**Town of Londonderry Planning Board  
268B Mammoth Road - Moose Hill Conference  
Agenda  
February 4, 2026  
7:00 p.m.**

- A. Public hearing for an application for formal review of a site plan for forty (40) residential units and a conditional use permit for 1,023 square feet of buffer impacts, including associated site improvements in the Commercial II (C-II) Zone. 225 Rockingham Road, Tax Map 15, Lot 126, Genex Construction Group, LLC (Owner/Applicant).

- i. Public hearing for an application for formal review of a site plan for a 48-unit multi-family residential development and a conditional use permit for 2,808 square feet of wetland impacts and 2,357 square feet of buffer impacts, including associated site improvements in the Commercial 1 (C-I) District. 222 Rockingham Road, Tax Map 15, Lot 150-1, Dark Horse Investments, LLC (Owner/Applicant).

A. Project Name: Rockpoint Commons 15 126  
(Map) (Lot)

SCALE: 1" = 20'      JUNE 12, 2025      SHEET 8 OF 33

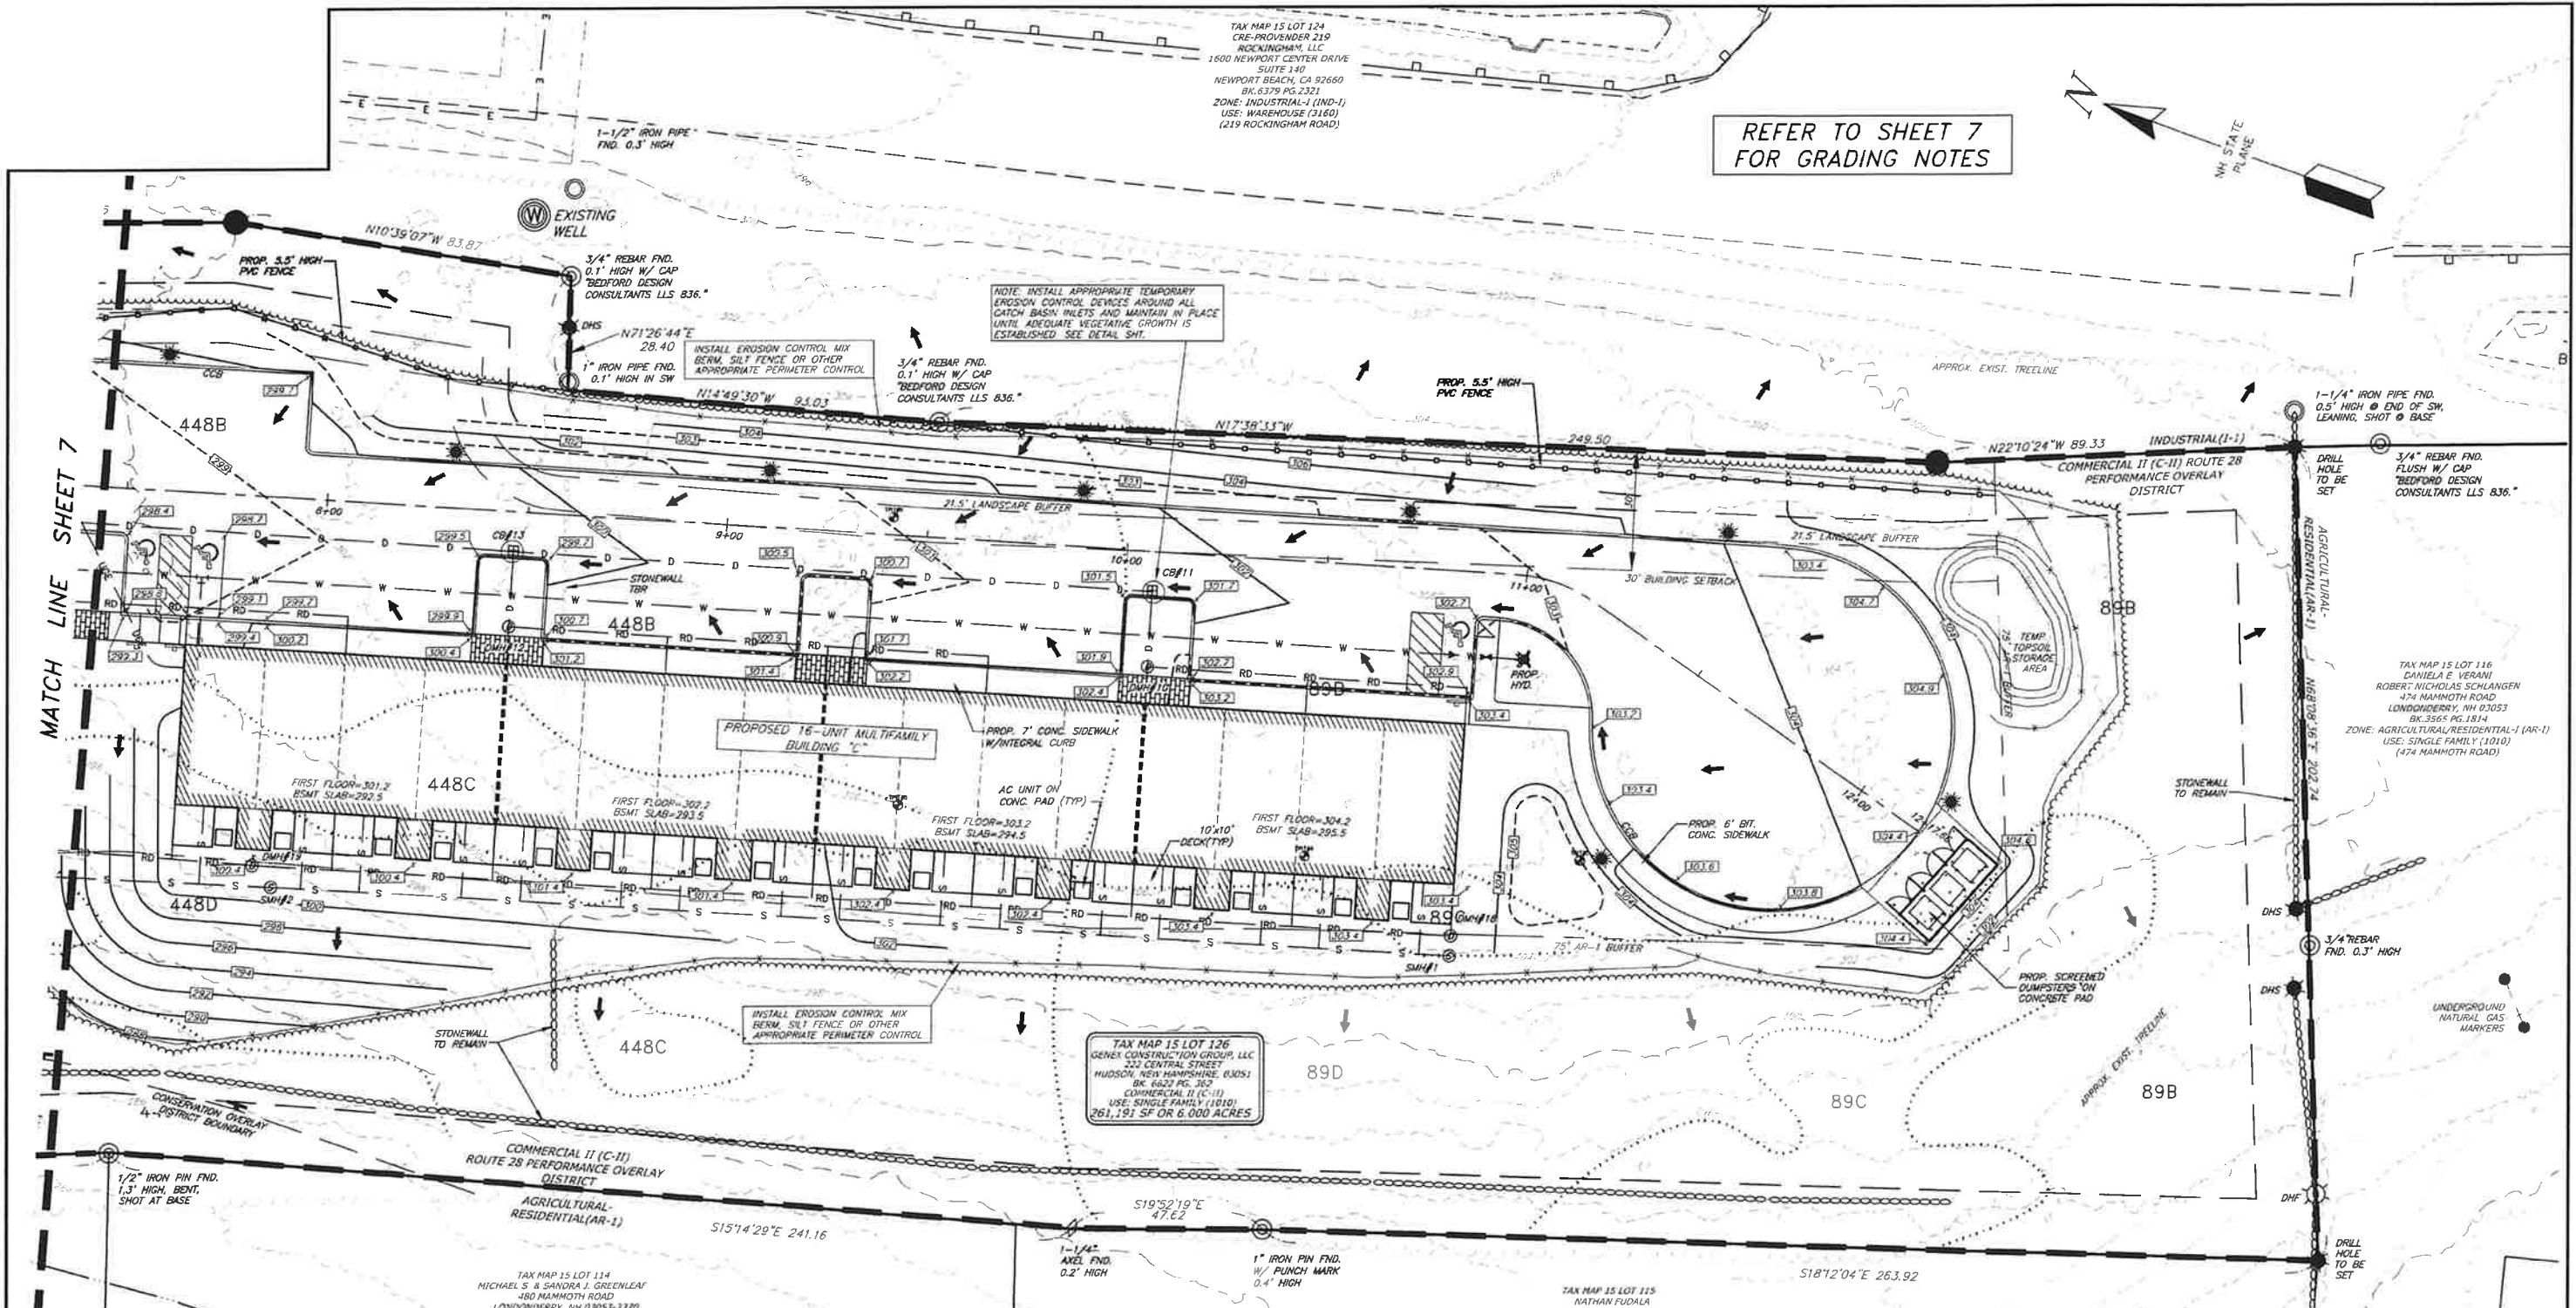
- f. The proposed grading along the easterly side of the driveway and parking lot shown on sheet 8 does not provide a proper 3H:1V embankment as typically requested by the Town. The revised design has noted the 2H:1V embankment slope as riprap. We recommend the design in this 2H:1V area include a guardrail along the parking area to NHDOT standards as typically requested by the Town. Please revise the design as acceptable to the Department of Engineering and Environmental Services.

- g. We recommend note 26 on sheet 10 (utility plan) be copied and provided on the grading plan – sheet 8 since the proposed detention basin grading is located within 5 feet of the existing gas line easement on the subject parcel. In addition, we recommend the Applicant provide documentation from the gas line Owner that they are aware of the proposed work in close proximity to the existing gas main under this project, as noted in the response letter, for inclusion in the Planning Board's project file.

**TDG Response:** *A table has been added to Sheet 8 summarizing the floodplain impacts.*

Drawn By: JHD  
Checked By: DGM  
Project: 640  
File: 640-SITE  
SHEET 5 of 24

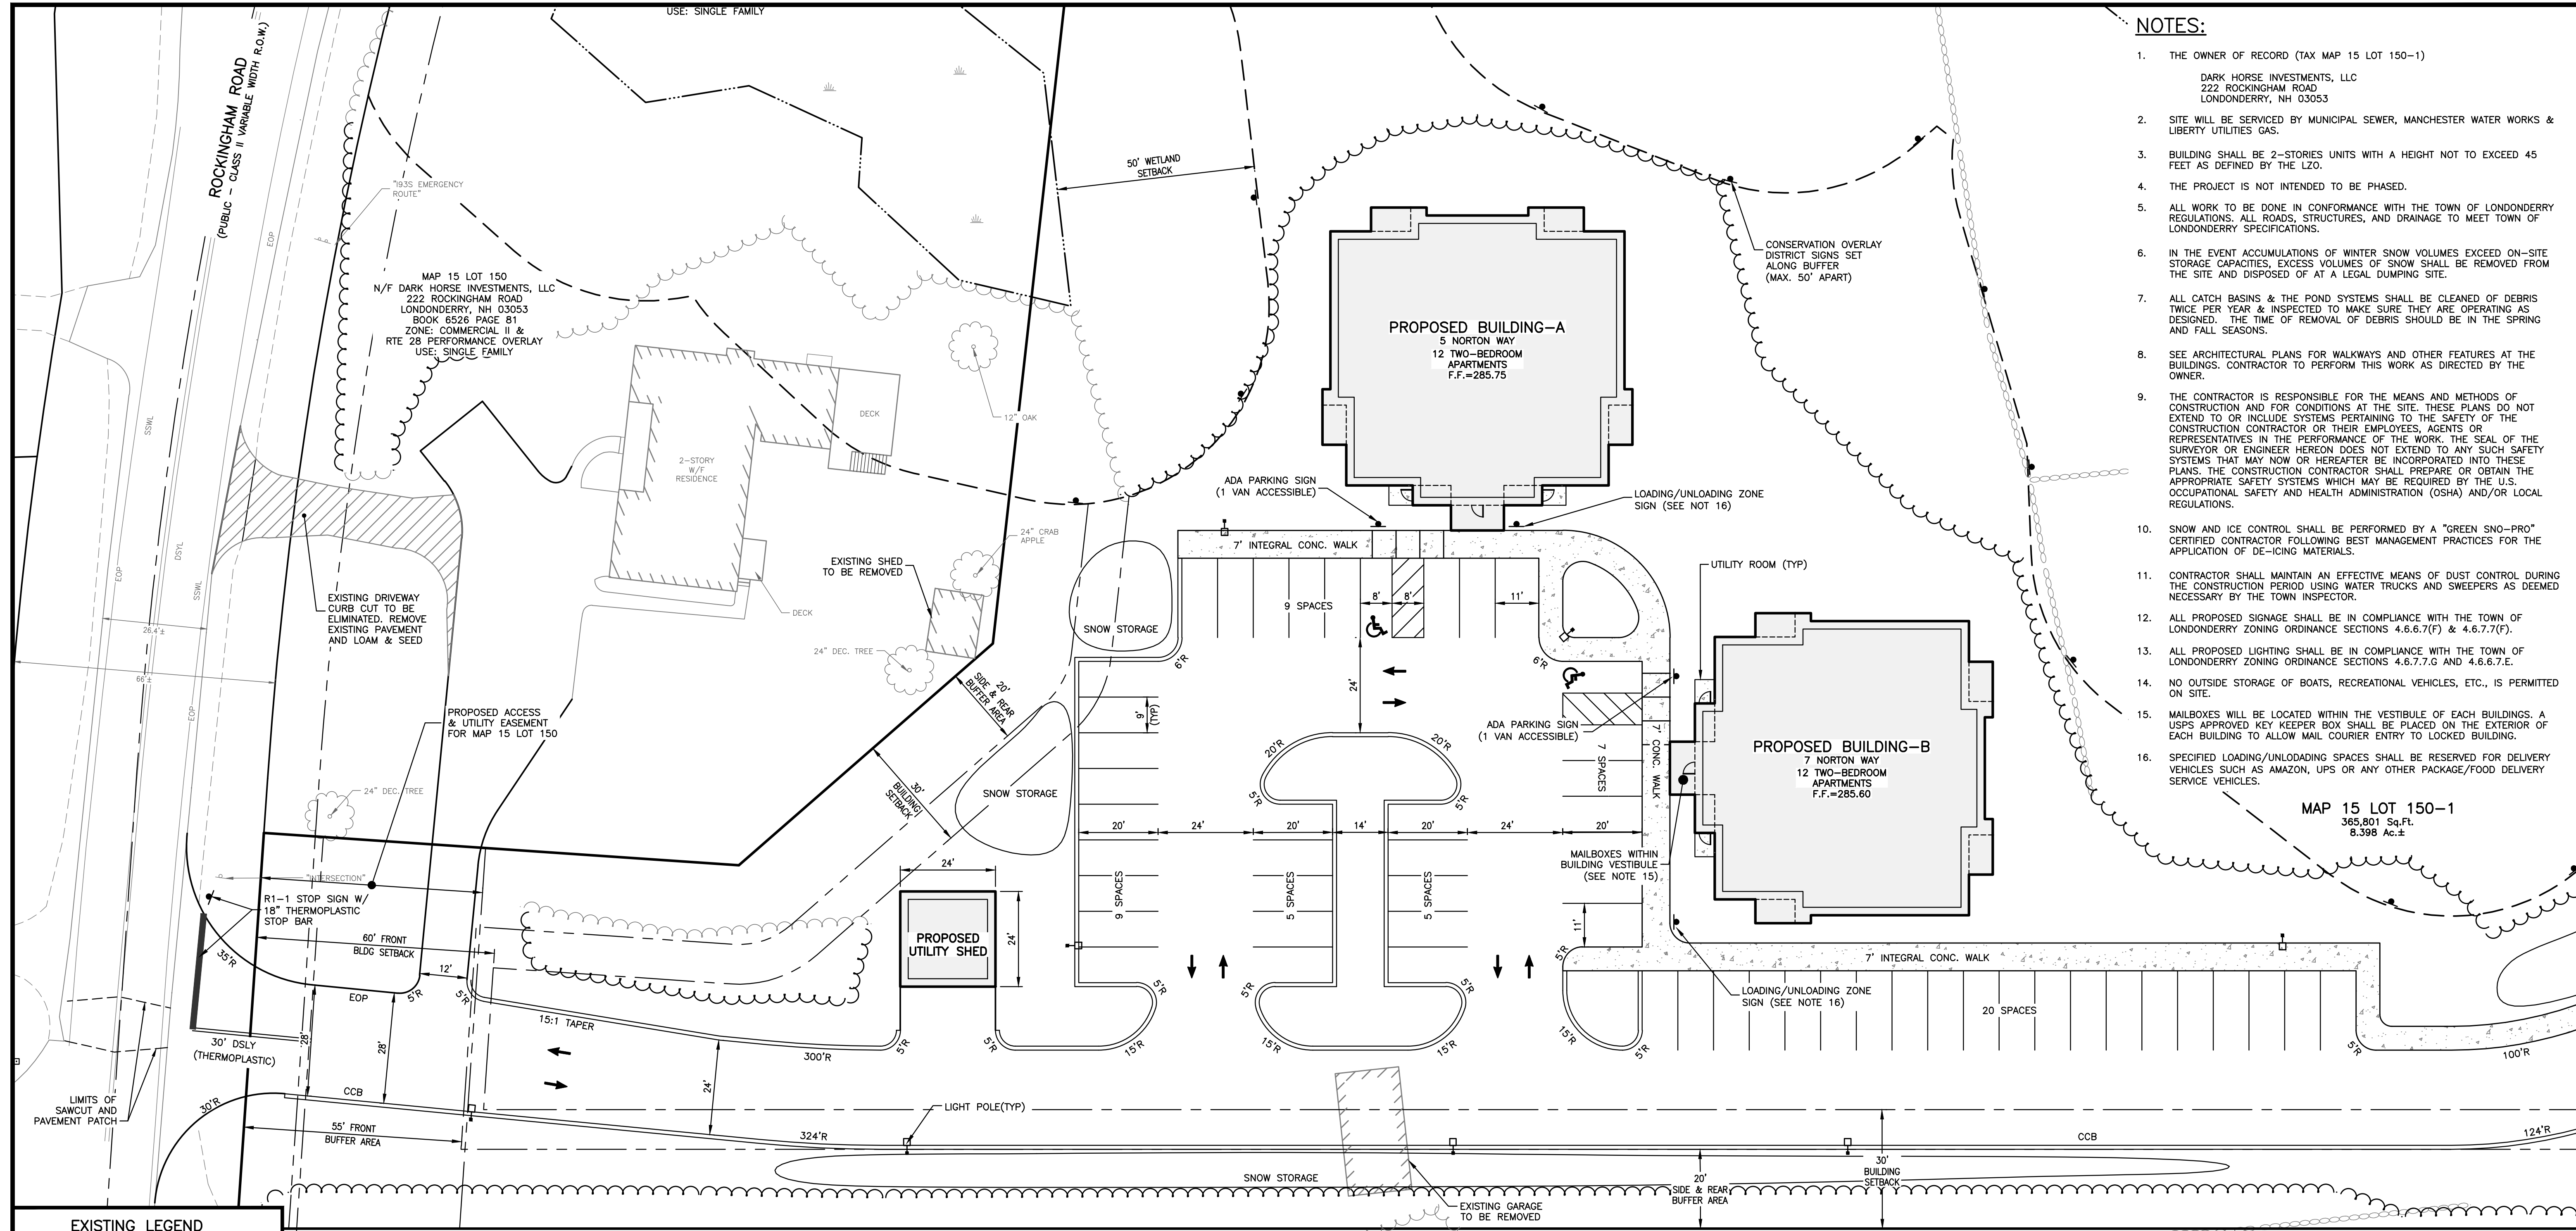
1. The submission information indicates a proposed common driveway to be shared by the two new lots and sheet 5 indicates the improvements for the common driveway and the associated impacts in the updated submission. However, the revised subdivision submission does not include a stormwater analysis/report per section 3.08 of the Subdivision Regulations and item X.3 of the Subdivision Application & Checklist for the indicated improvements to demonstrate the proposed improvements comply with section 3.08.A of no increase in runoff. We recommend the Applicant prepare and provide a stormwater analysis/report that addresses all the proposed development which demonstrates compliance with the Subdivision Regulations in accordance with section 3.08 and also demonstrates compliance with the Town's Stormwater Ordinance and Regulations under this application. The Applicant has noted a waiver has been requested in the response letter, but the request was absent from the submission.

**TDG Response:** *The expected delivery vehicle type has been noted in note 16 on sheet 5.*

**TDG Response:** *Note 3 on Sheet 5 has been expanded to include the number of stories.*

SHEET 13 of 24

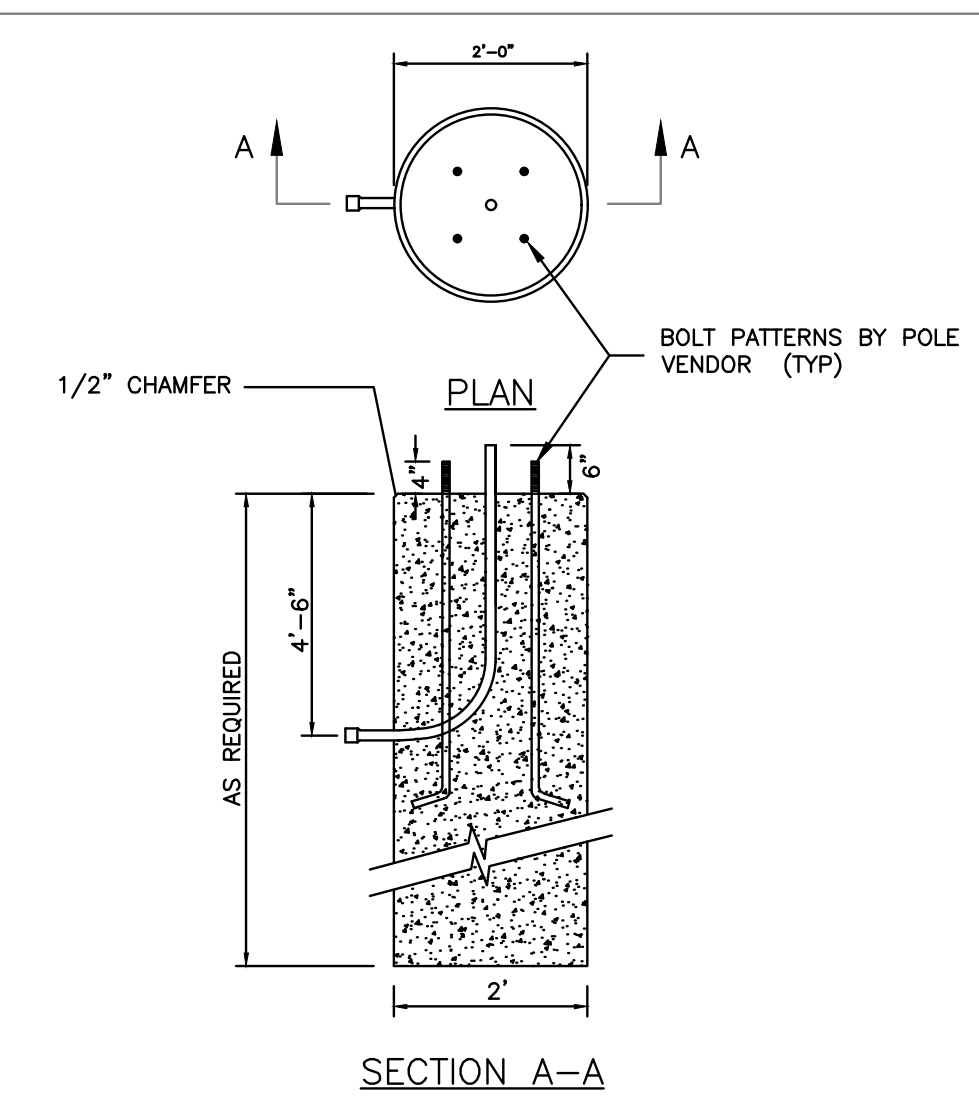
- l. Please remove the Planning Board signature block from the Landscape details - sheet 13 - per section 4.03 of the regulations.
